**CITY OF TEMPE
DEVELOPMENT REVIEW COMMISSION**

**Meeting Date: 10/08/2013
Agenda Item: 3**

ACTION: Request for an Amended Planned Area Development Overlay and a Development Plan Review consisting of two new 4-story multi-family buildings, totaling 358 units and approximately 672,000 sf. of building area for LPC SOUTHBANK, located at 1190 East Vista Del Lago Drive. The applicant is Snell & Wilmer LLP.

Sheet:
A1.1
 SITE PLAN

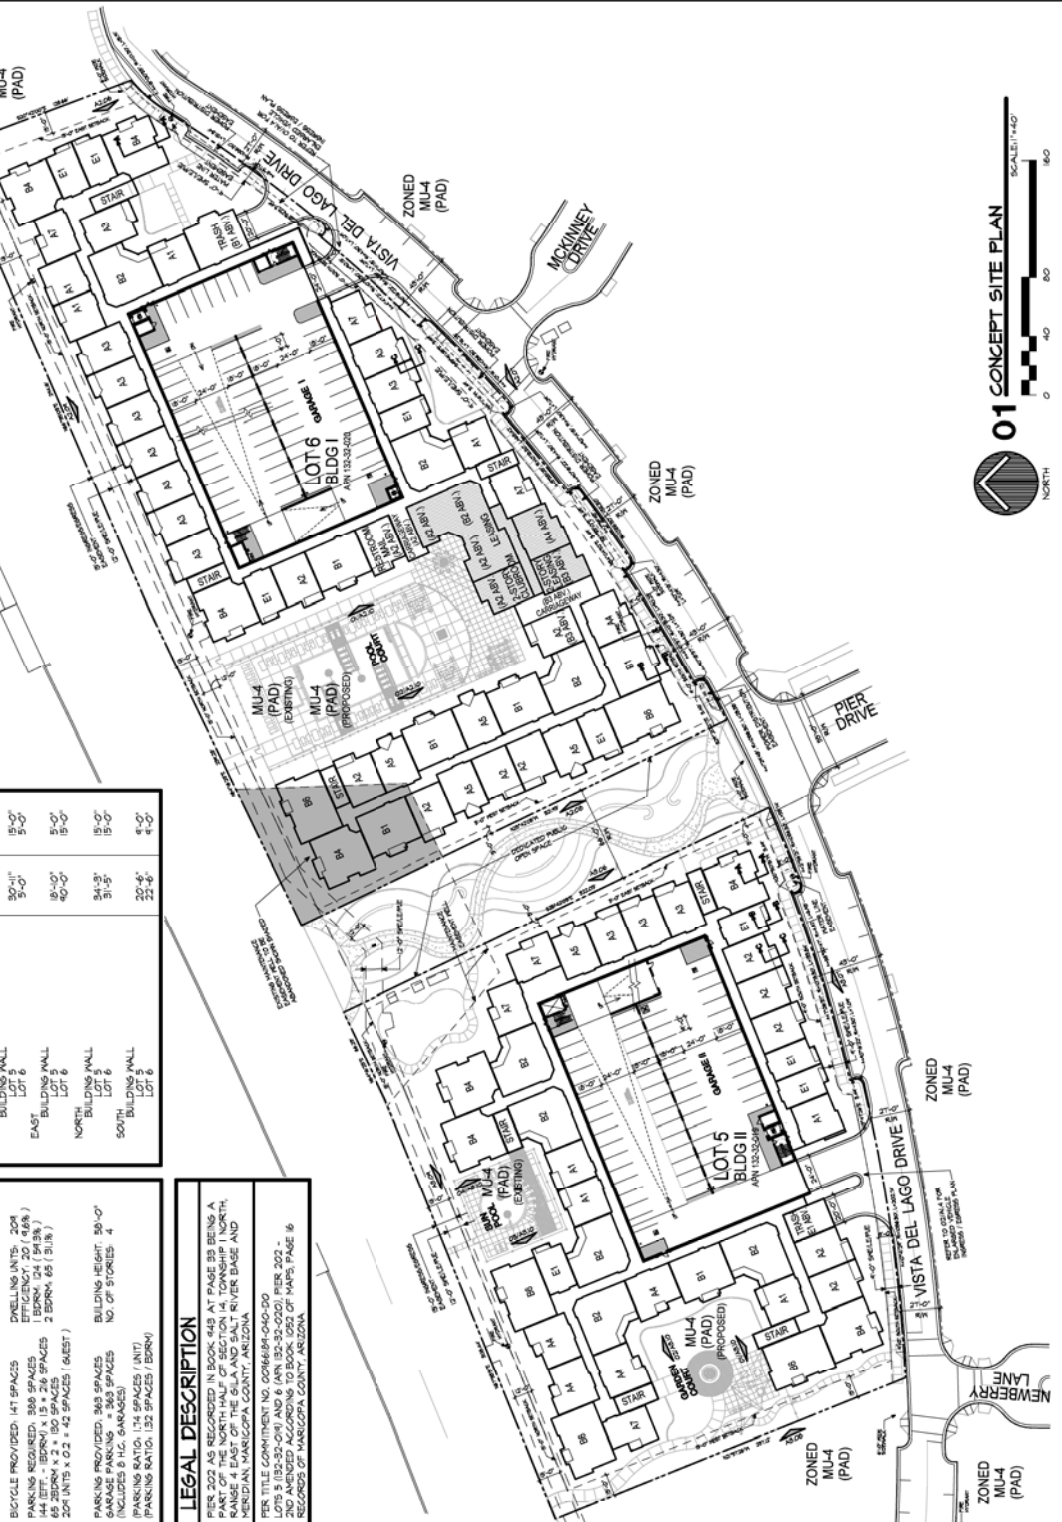
The site is located along the northern portion of the Southbank development site, consisting of Lots 5 and 6 and Tract B. The sites can be accessed off of Rio Salado Parkway from Pier Drive (lighted intersection), Newberry Lane or McKinney Drive. LPC (Lincoln Property Company) has proposed two separate buildings with separate garage parking for the residents and their guests. Lot 6, to the east, will provide the leasing office and club room amenities, within two floors of the building. There are a total of 4 private courtyard amenity areas, plus an additional common area tract separating both buildings. To the north of the site is the access control levee and linear park of the Tempe Town Lake. Pedestrian access from the street to the linear park can be provided by either through the building's stairwell exits and courtyards (for resident's use only) and through the common area tract between the buildings. The parking garage provides access to all levels of the building floors for residents. There is also on-street public parking which is not calculated into the parking provisions for this project. Based on a recent update to the site plan, the eastern parking garage is proposed where 4 existing parallel parking spaces area. A condition is proposed to address this layout.

10. Replace the four (4) existing public parking spaces located in the right-of-way along another portion of the site, subject to Traffic Engineering review. Additional easement and/or right-of-way dedication may be required to accommodate the sidewalk and on-street parking configuration.

11. The parking garages shall not be secured at the garage entry. If access control within the garage is desired, provide at least a 60'-0" stacking distance behind the sidewalk with unrestricted parking spaces available for guests.

12. Verify height of equipment and mounting base to ensure that wall height is adequate to fully screen the equipment. Locate electrical service entrance sections inside the service yard, as indicated.

LANDSCAPE PLAN

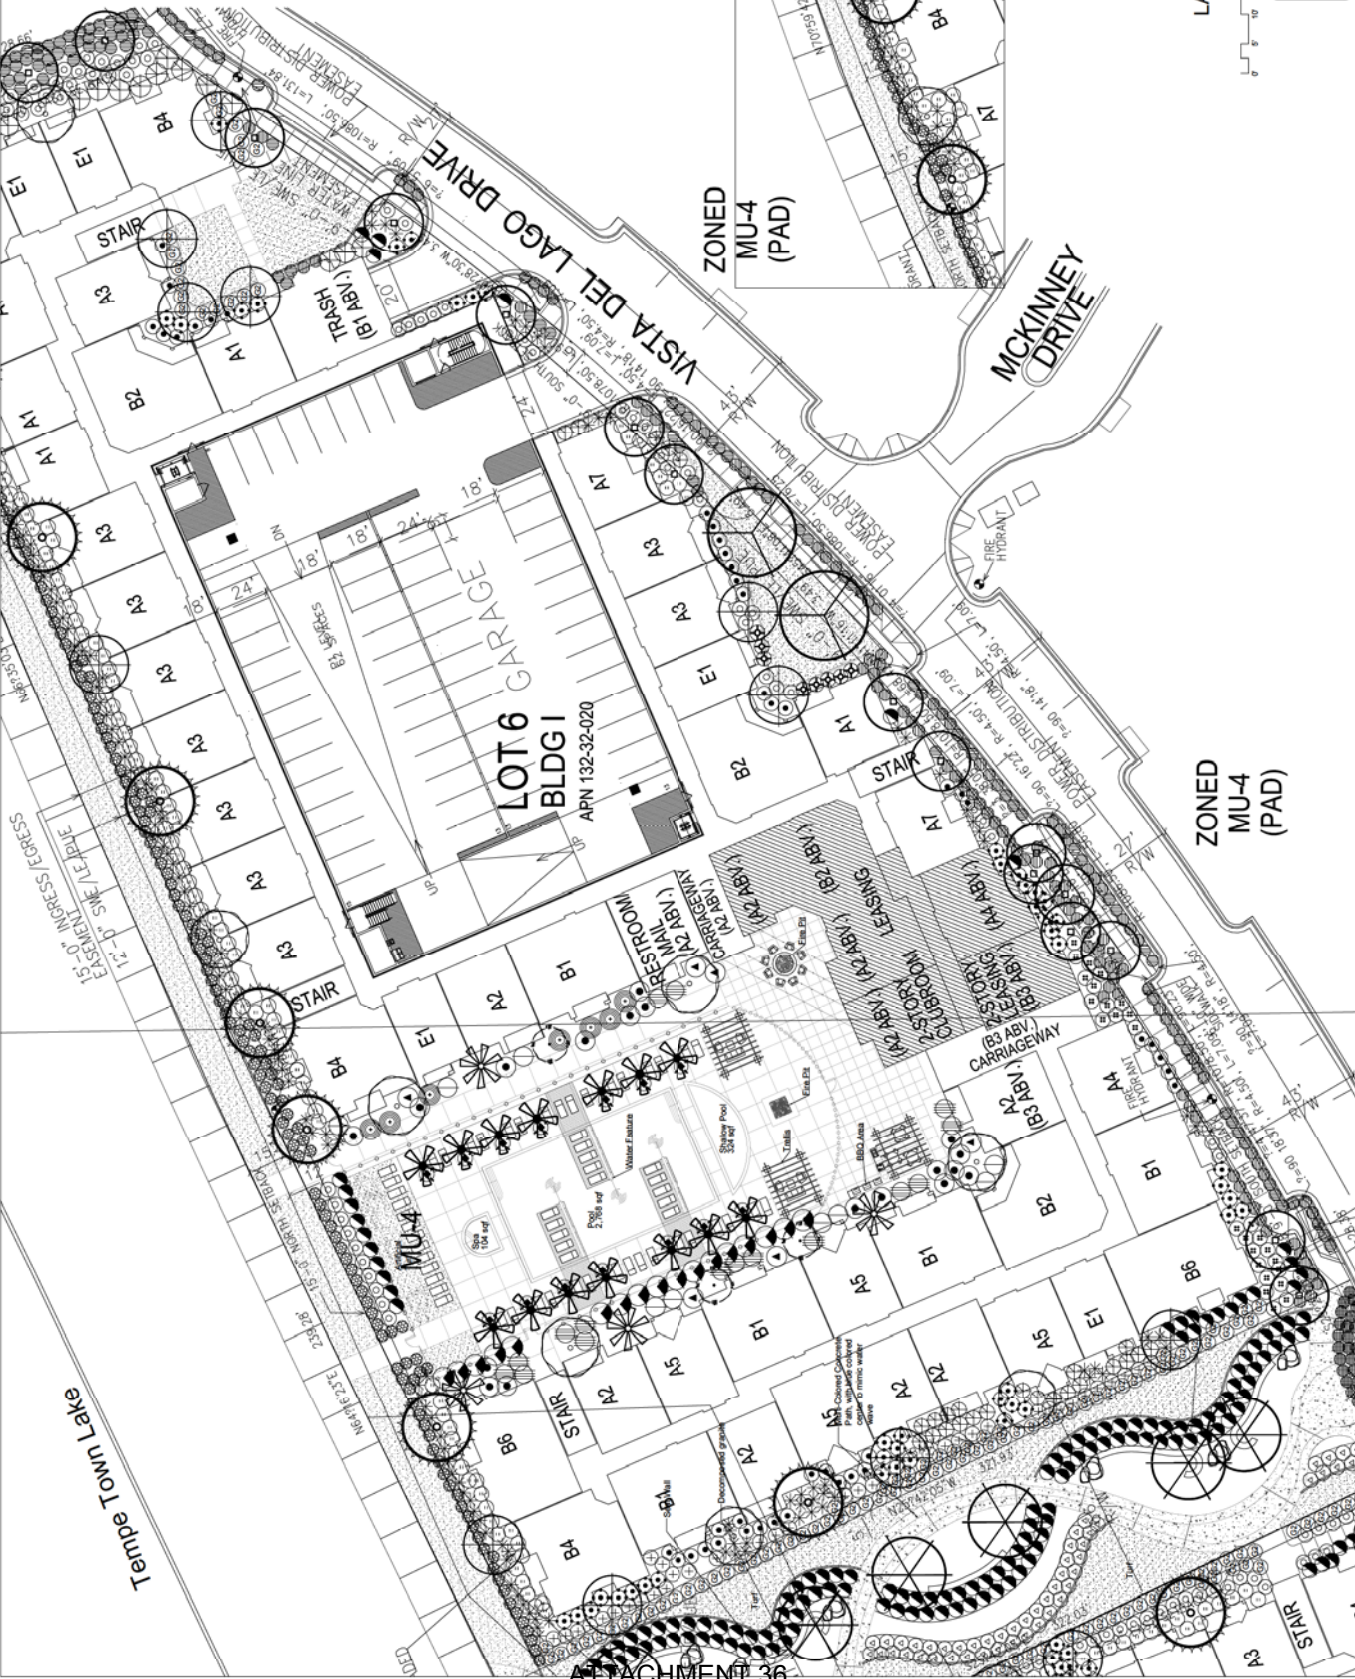
The proposed landscape plans, consistent with the original streetscape plan, will have a dedicated landscape strip with street trees along the curb edge, and along the inside edge providing a separation from the building units, with varied dimensions. The landscape palette as proposed is compatible with the Sonoran desert environment and provides a good mix of lower-water use plants that accentuate the hardscape elements private plaza courtyards. Between both development sites is a dedicated common area tract designed for public access and a view corridor to the Town Lake. Additional conditions are proposed for the common area tract to ensure that appropriate town lake amenities are integrated into the project site and this prominent location, such as benches and a designated art piece at the focal point of the entrance. Staff recommends approval of the landscape and hardscape plans, subject to the conditions of approval.

- 32. The plant palette is approved as proposed, unless otherwise specified within the conditions. Any additions or modifications may be submitted for review during building plan check process.
- 33. Provide Dalbergia Sissoo trees along the street frontage adjacent to the street curb, on the south side of the sidewalk. Where the street curb is adjacent to parking spaces, provide the trees and ground covers within a landscape island and provide sidewalk paving connecting the sidewalk between the spaces. Provide at least one tree for every 30' of lineal street frontage.

39. Trees shall be planted a minimum of 12'-0" from any existing or proposed public water or sewer lines located on-site. Trees near the main water or sewer lines located within the right of way shall be planted at least 20'-0" away. Final approval subject to determination by the Public Works, Water Utilities Division.
